Re: **Revised Conceptual Plan for Sludge and Soil Sampling
Holloman Air Force Base, NM**

**RESULTS OF CONFERENCE CALL FOR
SEWAGE LAGOON SAMPLING
HOLLOMAN AFB, NEW MEXICO**

**CONCEPTUAL PLAN FOR SLUDGE AND SOIL
SAMPLING AT THE SEWAGE LAGOONS
HOLLOMAN AIR FORCE BASE, NM**

28 October 1991
Revised 11 November 1991

Figure 2-1. Sample Locations--Ponds C, D, E, and F

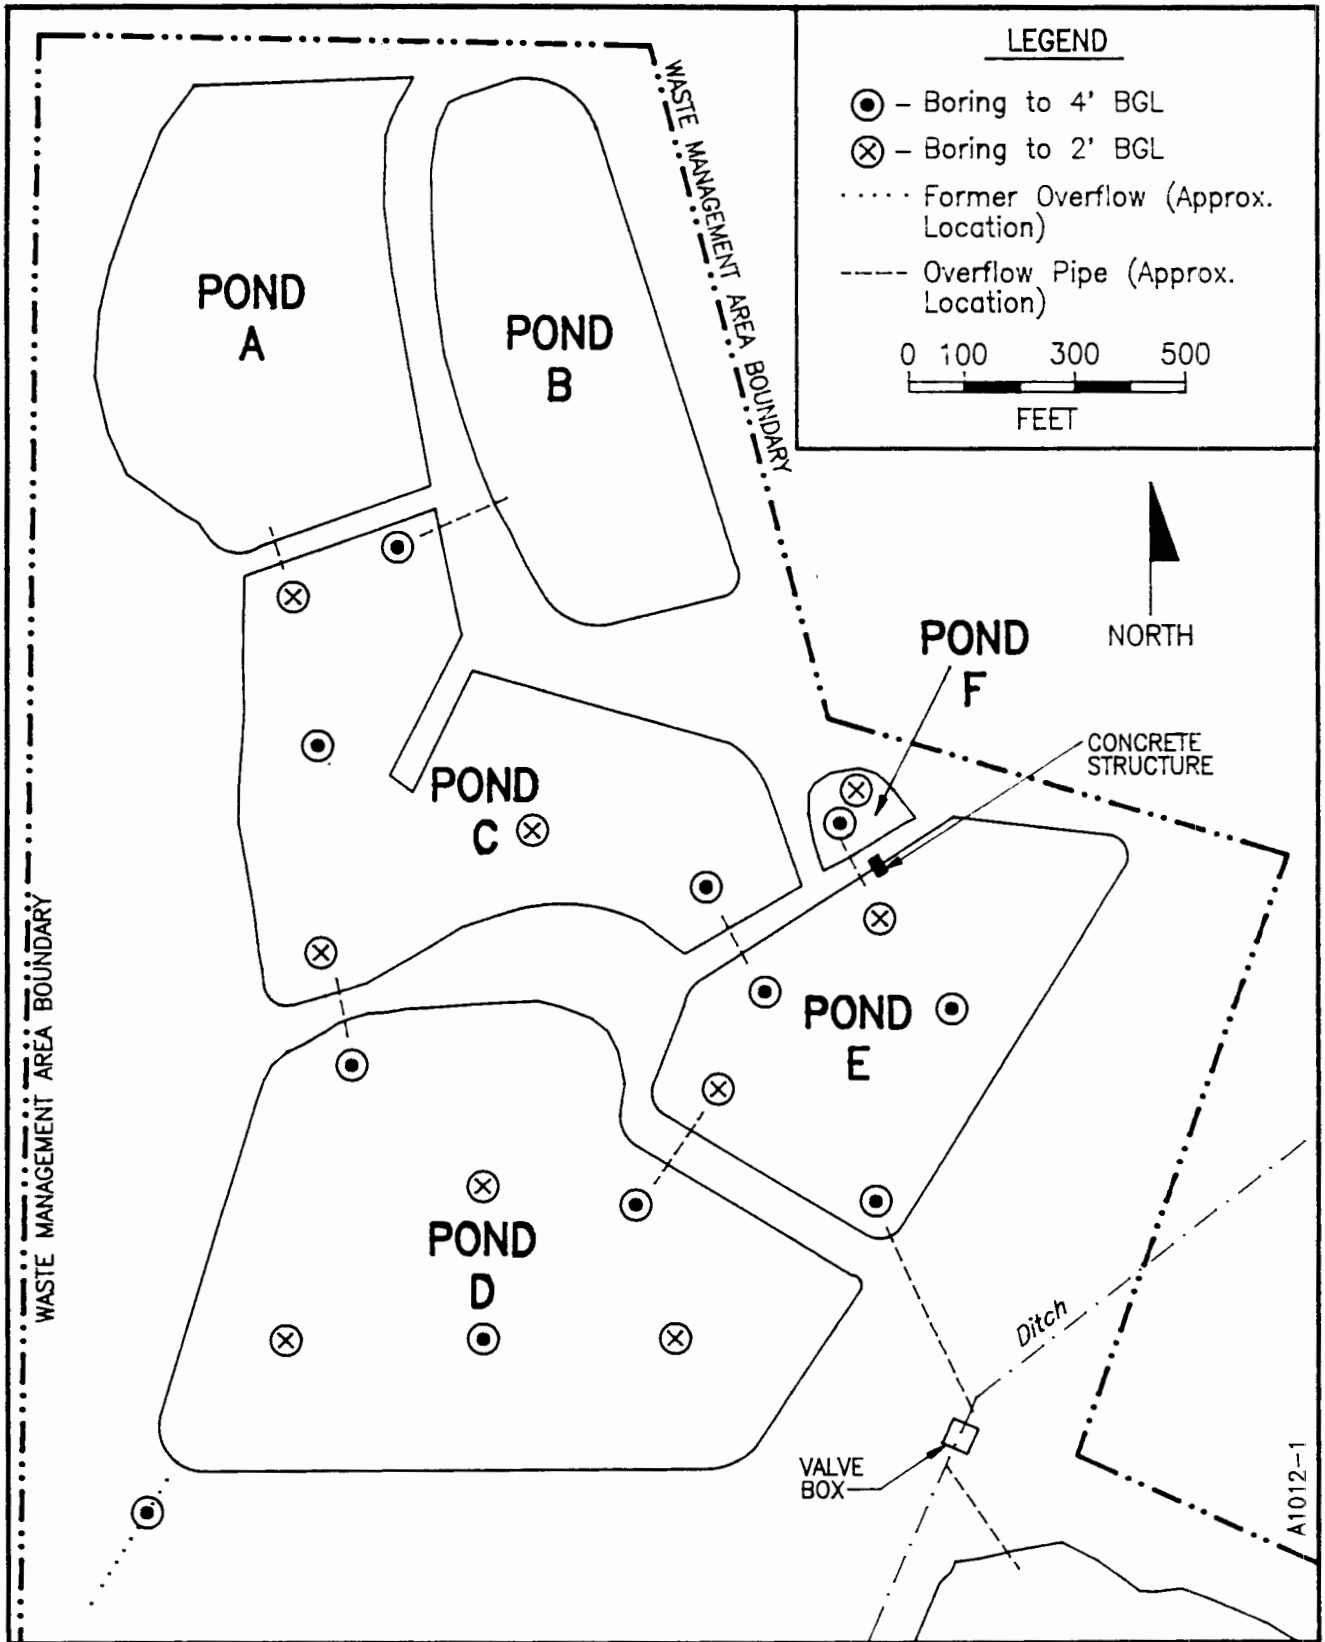
The number of samples in the northern portion of Pond C is inadequate. Specifically, a sample should be located at each of the overflow points from Ponds A and B.

The number of samples in Pond E is inadequate. Specifically, one sample should be located at the overflow point from Pond D, and one at the overflow point to Pond G.

Although historical data exist for sampling in this area, two sampling points will be added, one at each of the overflow points. One sample point will consist of a boring to 2 feet bgl and the other to 4 feet bgl (total of five additional samples for Appendix IX analysis).

One sample point will be added at the overflow point from Pond D, consisting of a boring to 4 feet bgl, and one of the existing sample points in Pond E will be repositioned near the overflow to Pond G (total of three additional samples for Appendix IX analysis).

Figure 2-2. Sample Locations--Pond G

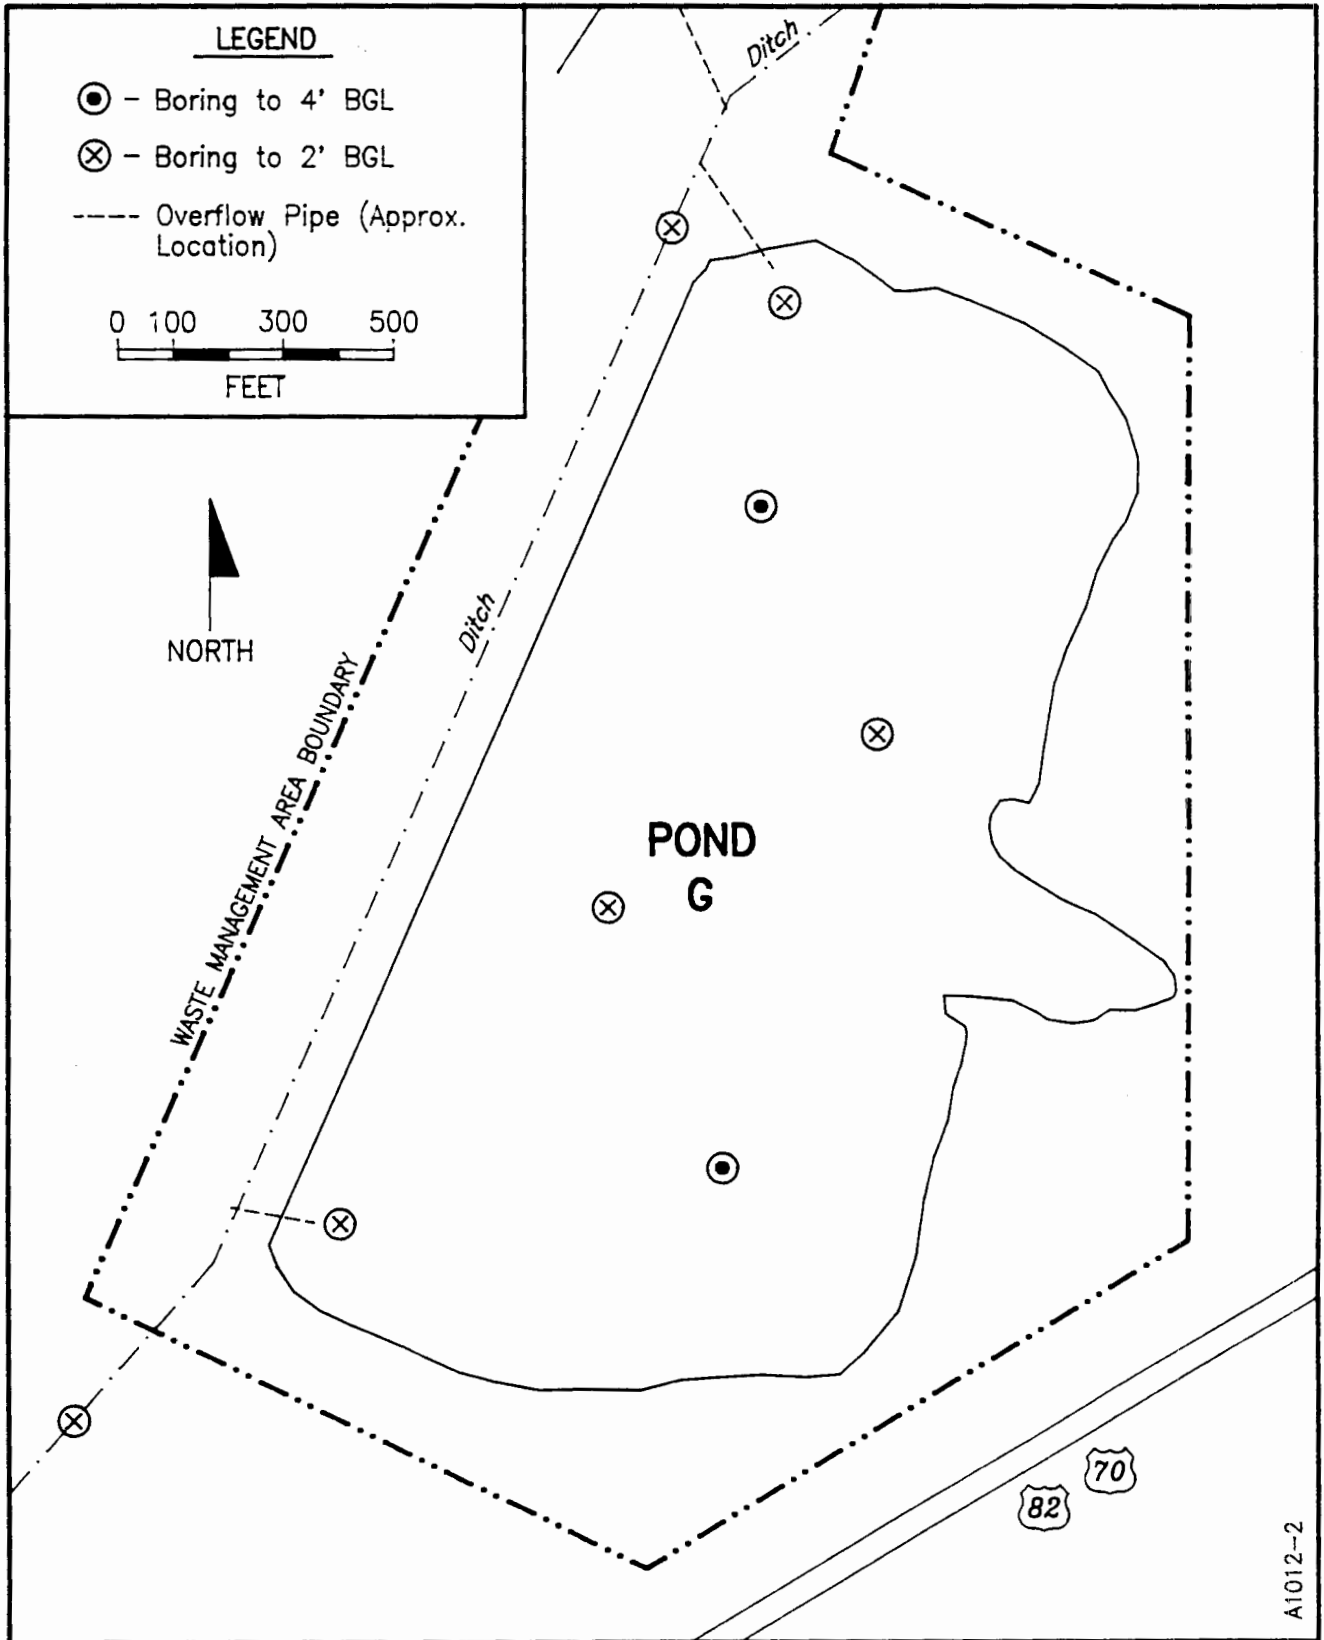
The number of samples in the ditch from Pond G to Lake Holloman is inadequate. Specifically, a sample should be located in the portion of the ditch flowing along the western side of Pond G.

A valve box is located between Ponds E and G to control the overflow and ensure that wastewater effluent does not bypass Pond G into the ditch. The portion of the ditch under consideration handles storm water runoff from the Base. A sample point will be located in the ditch "downstream" of the valve box to ensure that this device has functioned properly in the past. The sample point will consist of a boring to 2 feet bgl (total of 2 additional samples for Appendix IX analysis).

Figure 2-3. Sample Locations--Lakes Holloman and Stinky

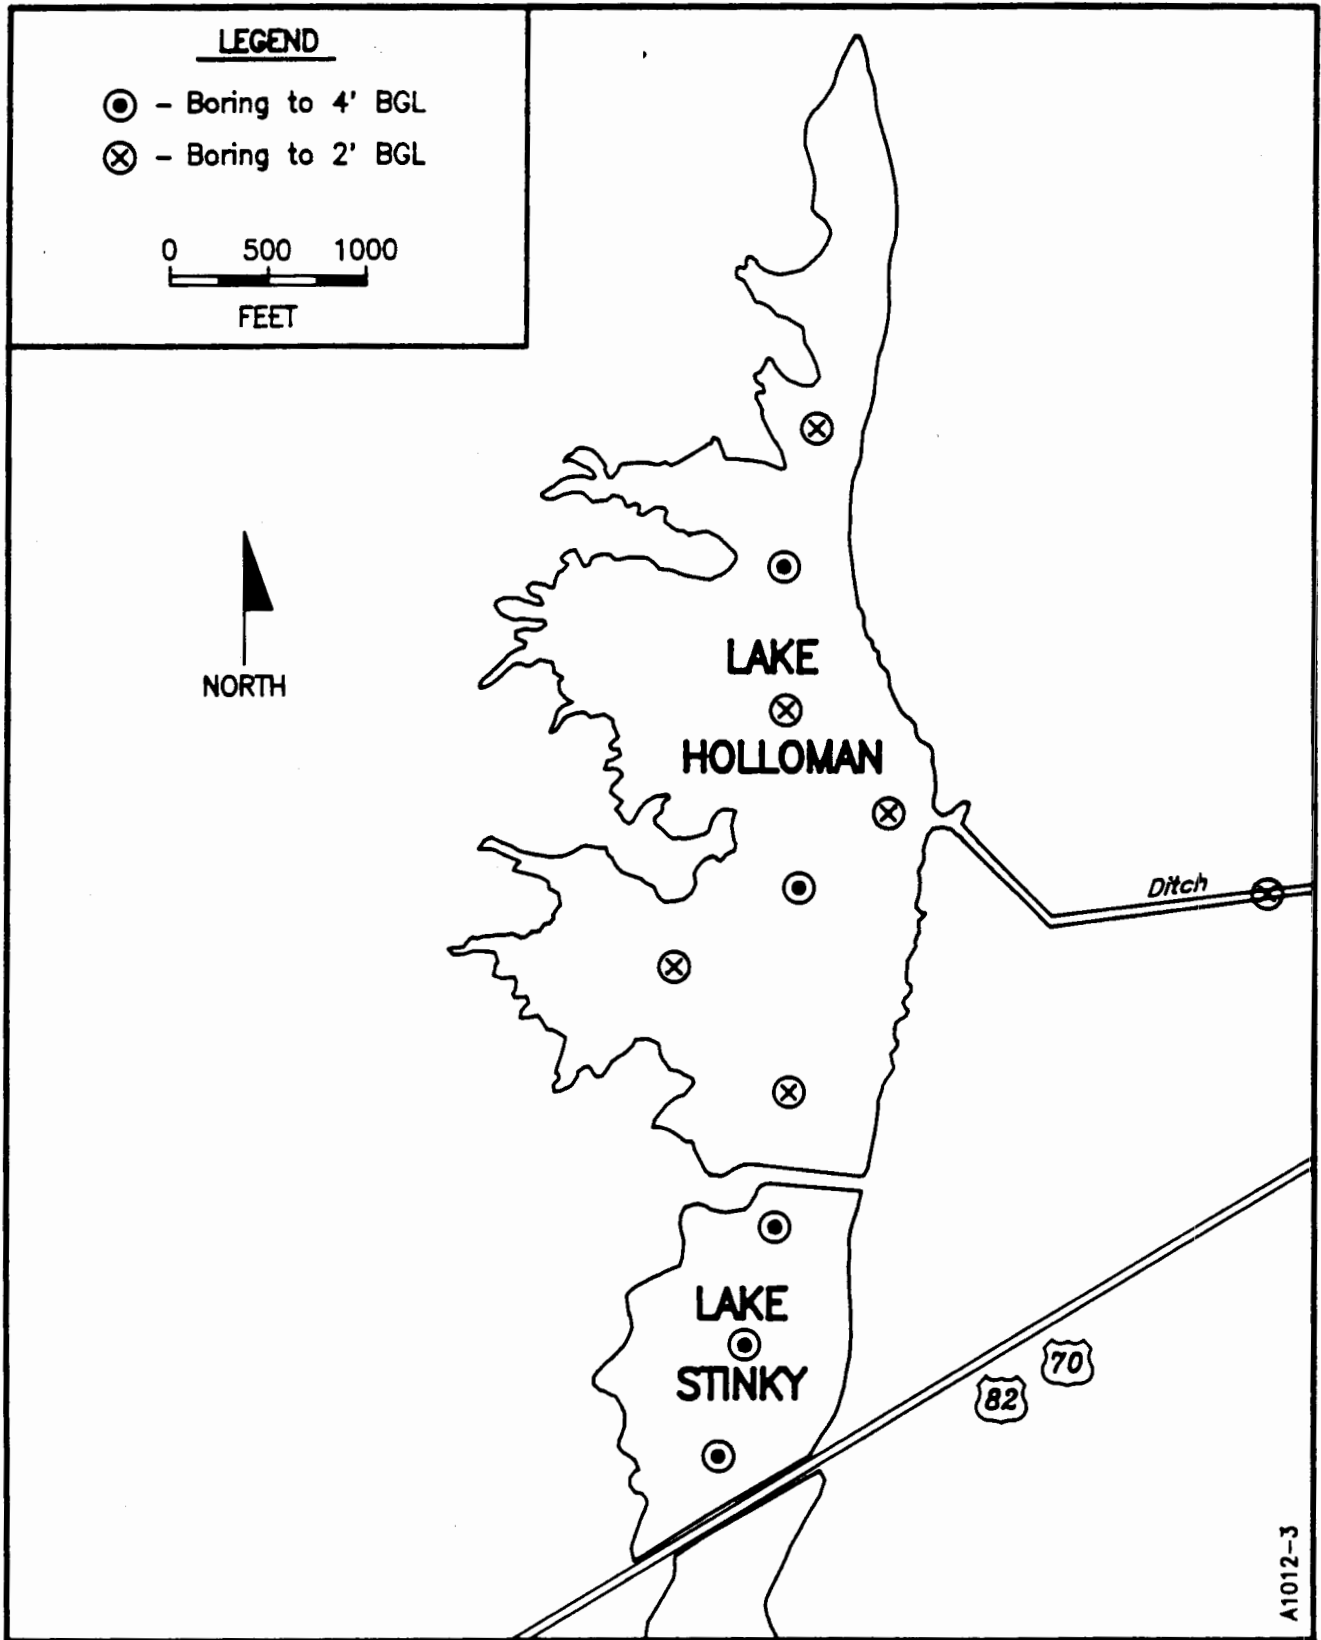
The number of samples in Lakes Holloman and Stinky is inadequate.

Considering the relative size of the lakes with respect to the rest of the sewage lagoon system, the number of samples may appear inadequate. However, the proposed investigation is recognized to be an interim measure providing data to allow the lagoons to operate during the delay-of-closure period, and is not intended as a demonstration of clean closure. In addition, these impoundments are not covered under the Federal Facilities Compliance Agreement (FFCA), and samples are being collected to comply with requirements of the Bureau of Land Management (BLM) and the Fish & Wildlife Service (FWS). Therefore, no additional samples will be collected from the lakes during this phase of investigation.
